CITY PLAN COMMISSION**FILE NUMBER:** PLAT-25-000161**THURSDAY, January 15, 2026****SENIOR PLANNER:** Hema Sharma**LOCATION:** Cliffview Drive, south of C.F. Hawn Freeway/U.S. Highway No. 175**DATE FILED:** December 18, 2025**ZONING:** MH(A)**CITY COUNCIL DISTRICT:** 8**SIZE OF REQUEST:** 2.437-acres**APPLICANT/OWNER:** OW Ridgecrest II LLC

REQUEST: An application to create one 2.437-acre lot from a tract of land in City Block 7842 on property located on Cliffview Drive, south of C.F. Hawn Freeway/U.S. Highway No. 175.

PLAT-25-000161

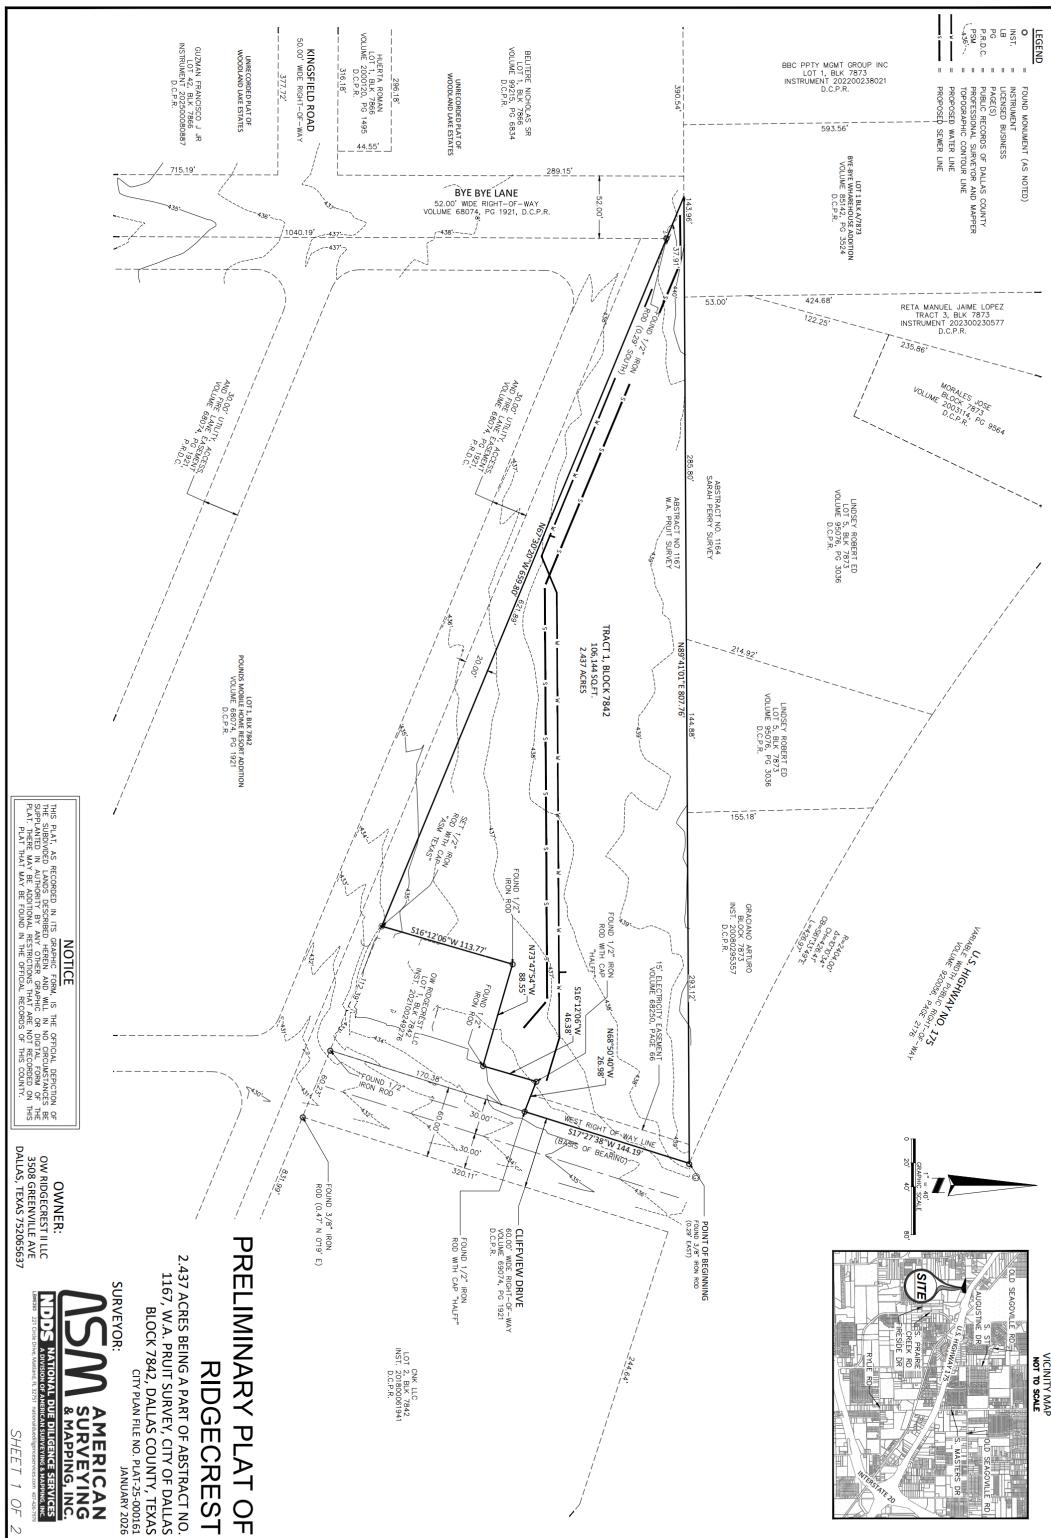
16. Prior to final plat, submit a completed final plat checklist and all supporting documents.
17. On the final plat, show how all adjoining right-of-way was created. *Section 51A-8.403(a)(1)(A)(xxii).*
18. On the final plat, show distances/width across all adjoining right-of-way
19. On the final plat, show recording information on all existing easements within 150 feet of the property.
20. On the final plat, show all additions or tracts of land within 150 feet of the property with recording information. *Platting Guidelines.*
21. On the final plat, use standard Owner's dedication.

25. Prior to final plat, a revised tree survey with tree size and species are required. Current tree survey labeled "2523638 Dallas TX SS Survey 8-14-25" is missing tree species.
26. On the final plat, change "Kingsfield Road" to "Kingsfield Road (FKA John Rowland Road)". Section 51A-8.403(a)(1)(A)(xii).
27. On the final plat, change "U.S. Highway No. 175" to "C.F. Hawn Freeway/U.S. Highway No. 175 (FKA Second Avenue)". Section 51A-8.403(a)(1)(A)(xii).
28. On the final plat, identify the property as Lot 1 in City Block A/7842.
